NUMBER: 08-007-03

Alternator Mounting Bracket Cracked

This bulletin involves replacing the alternator support bracket with a revised bracket.

2003 (DR) Ram Truck

**Fig. 1 ALTERNATOR WIRING HARNESS MOUNTING**

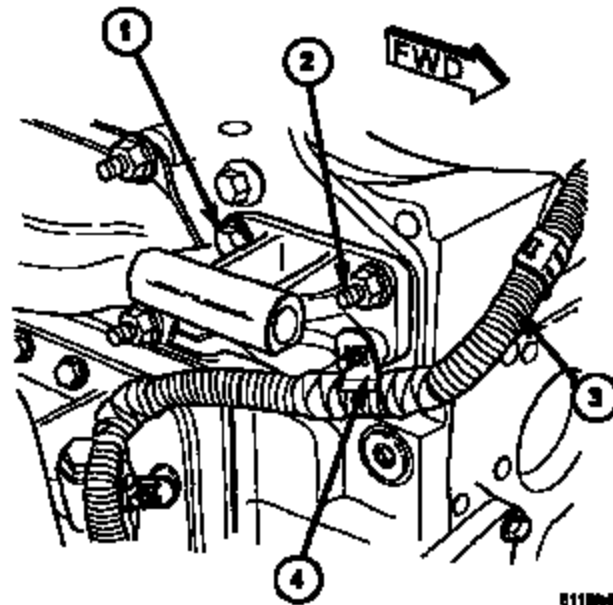
8. Install the replacement alternator support bracket (p/n 05086742AB) utilizing the four new bolts. Position the two studded bolts (p/n 05093136AA) at the front of the bracket as shown in (Fig. 1). Position the two hex head bolts (p/n 04429114) at the rear of the bracket.

- 
9. Tighten all four bracket mounting bolts to 25 Nm (18 ft. lbs.).
  10. Attach the alternator wiring harness clip over the lower stud as shown in (Fig. 1).
  11. Rotate the alternator back into position and fasten with the upper mounting bolt/nut. Tighten the nut to 41 Nm (30 ft. lbs.).
  12. Tighten the lower alternator mounting bolt to 41 Nm (30 ft. lbs.).
  13. Carefully remove the clip connector from the grid heater harness and discard.
  14. Fasten the new push-on wiring clip (p/n 05127471AA) to the grid heater harness using electrical/friction tape. Verify that the clip is aligned with the appropriate mounting stud.
  15. Press the wiring clip over the end of the upper mounting bracket stud (Fig. 2).
